Brooks Landing Phase II Public Improvements
Visual Preference Survey

Site Area 1
Elmwood Underpass

Site Area 2
Overlook

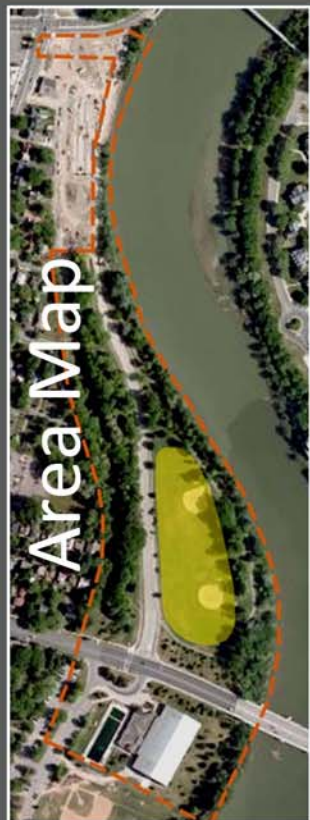
Comments on Overlook:

- Do not make too elaborate so as to not detract from river views.
- Do not construct a roofed structure.
- Add at least one additional overlook.
- Push out more towards river.

Comments on Benches:

- Need to be comfortable and have arms.
- Should be easy to keep clean.
- Benches with backs.

Comments on Railings:

- Nothing too modern looking.
- Traditional railing.

Site Area 3
Baseball fields

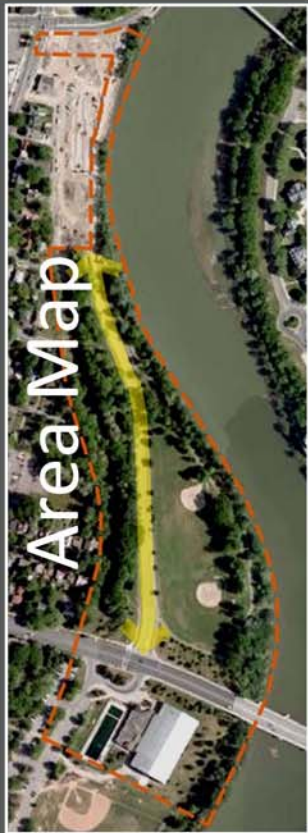
Comments on Programming:

- Remove baseball fields, already have them south of Elmwood.
- Create a dog area.
- Add a multi-use field.
- Do not overlap ball and multi-purpose fields.

Comments on Field Location:

- Make the fields easily walkable from parking area.

Comments on Field Configuration:

- Pull ball fields close to one another.
- Keep in mind location of the sun during times that fields are in use.

Site Area 5
Grove of Trees

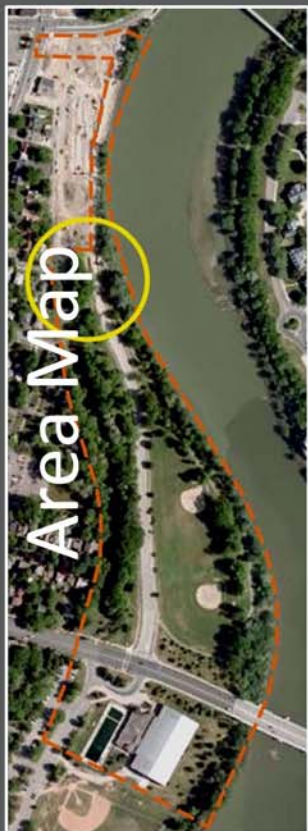
Comments on Benches:

- Just include benches, no picnic tables, as introducing tables may invite garbage.
- Benches with backs.

Comments on Clearing:

- Maintain existing trees and look at adding new young trees.
- Choose strong sight lines.
- Open up river edge.

Comments on Landscape & Amenities:

- No flower beds.

Site Area 8
Neighborhood
Interface

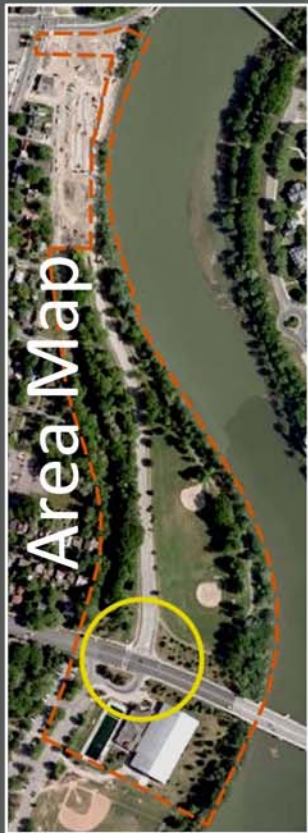
Comments on Connections to Neighborhood:

- Make connections with neighborhood.
- No stairs, only ramps if needed.
- Important to ask neighbors at the end of each street.

Comments on Pathway:

- Make pathways accessible, and natural.
- Stone dust paths are preferred.
- Keep area green.

Comments on Clearing:

- Clean out some brush growth and dead trees.
- Like it as is, very natural.
